INDESIT company

Model type:
AVSD109SEX

Commercial code:
F029993

n1040325: New shock absorber fixing system with pin

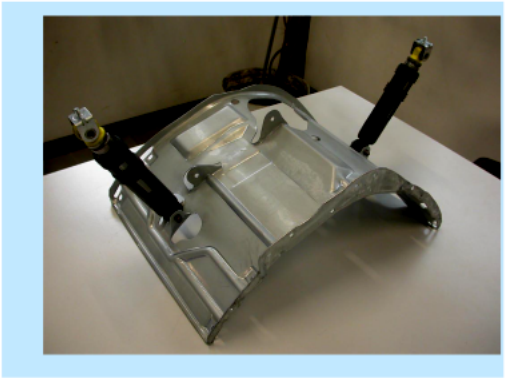
From serial no. 40427.0001, shock absorbers have been fixed to the tank unit cradle with two 11 mm pins code C00110163 (see fig. 01 and 02 enclosed) in place of the 8 mm screws code 093750 and relevant locking nuts code 030443, on all washing

machines and dryers produced in the Comunanza factory.
The items affected by this modification are:
1) The cradles have the same Service code, as they can be used in place of the new ones after widening the shock absorber fixing holes to a diameter of 10 mm.
Code 093848 - Tank unit cradle 46 lt
Code 093878 - Tank unit cradle 40 lt.
2) The new shock absorbers, with fixing bushing having no s/steel spacer, are not managed as they are interchangeable with the premodified items (make sure they are CIMA type, as the managed items), fixed with M8 screws code 093750 and related locking nut code 030443 (see figs. 05 and 06).
Code 093884 - Shock absorber 80 N
Code 093885 - Shock absorber 100 N

To remove the shock absorber from the tank, first extract the pin with a few hammer taps (see fig.03) until it is aligned with the tank bracket and then pull it out with a pair of pliers (see fig. 04).
(To refit the shock absorber use a new pin. Insert the pin until the toroidal edge is aligned with the bracket.)

n1040326: Two-bearing mechanism on Slim range washing machines

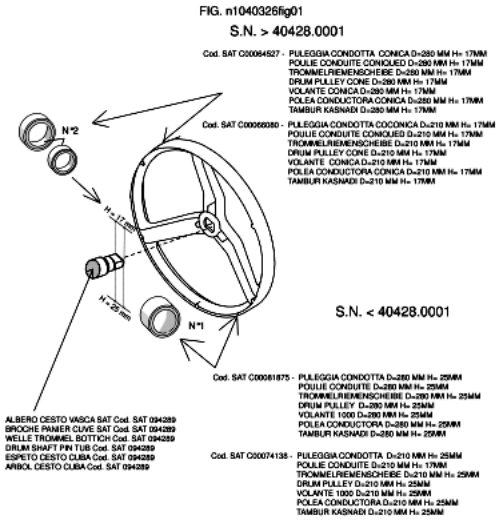
From serial no. 40428.0001, all Slim range models produced in the Comunanza factory have been equipped with a two-bearing mechanism in place of the single-bearing one.

The Service codes of the new mechanism are:
Service code C00096186 - SEAL RING CV4;
Service code C00002591 - BEARING 20X47X14 6204 SKF;
Service code C00013563 - BEARING 25 X52 X 15 6205 - 2Z SKF;
Service code C00110340 - CROSS WITH SEAL RING (2C) SNELLA;
Service code C00094289 - EVO 40L TANK SLIM (1-C) > (2-C)EVOII;
Service code C00094290 - OUTER- SET 40 L.(1-C)>(2-C)EVOII;
Service code C00064527 - DRIVEN PULLEY CONE D=280 MM H= 17MM;
Service code C00066080 - DRIVEN PULLEY CONE D= 210 MM H=17 MM.

The tank assembly with the new two-bearing cross has the same Service code as the single-bearing one (C00094289); the latter will be available until stocks run out.
When replacing the tank, make sure that the value H (17 mm or 25 mm) of the basket cross shaft corresponds to the value H of the pulley (see Fig.001).

The following premodified items will continue to be used:
Service code C00026298 - BEARING BA2B 633667 30X60.03X37;
Service code C00039667 - SEAL RING;
Service code C00074137 - CROSS WITH SEAL RING;
Service code C00081875 - DRIVEN PULLEY D=280MM H=25MM;
Service code C00074138 - DRIVEN PULLEY D = 210MM H=25MM;
Service code C00026299 - SEEGER RING SB 60X1,5.

Fig . 001

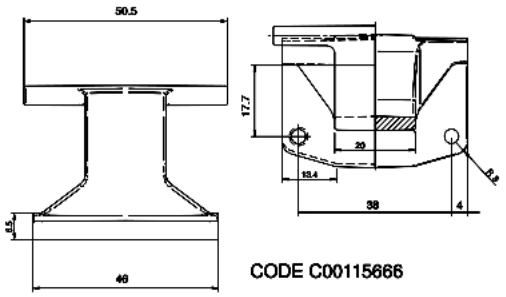
n1040349: Introduction of 150° Zamac hinge on Ariston 46 models.

From serial no. 50207.0001, all Ariston models produced in the Teverola factory (see table 001 attached) with industrial code (given on the rating plate) starting with 46, have been equipped with a Zamac hinge with 150° opening angle, code C00115666 (see Fig.001).
This modification has involved the introduction of the following items:

Code C00115670 - Complete door EVOII 150° white 27 with standard glass;
Code C00115674 - Complete door EVOII 150° white 27 with long glass;
Code C00115667 - EVOII body for 150° hinge white 27;

The premodified items are not interchangeable separately with the modified ones.

The hinge code C00064541 continues to be used on the build-under models produced in the Comunanza factory.

Fig . 001

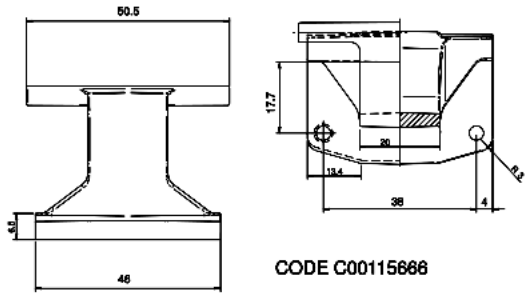
n1040378: 3.5 three phase module, factory 80 (Comunanza)

From October 2005, the new 3.5 module has been installed on three phase Comunanza models (80)

C00254298 - Three phase module for card LB-WD 3.5;
C00141769 - J10-MV J16-EVA/NT WD cables (see picture attached).

Premodification parts:
C00257406 - MODULO WD>1200 G. +SC FW2.74 (CARD)
C00093717 - Cables J10-EWA MV NT WD.

The new items are not interchangeable with the premodification ones.
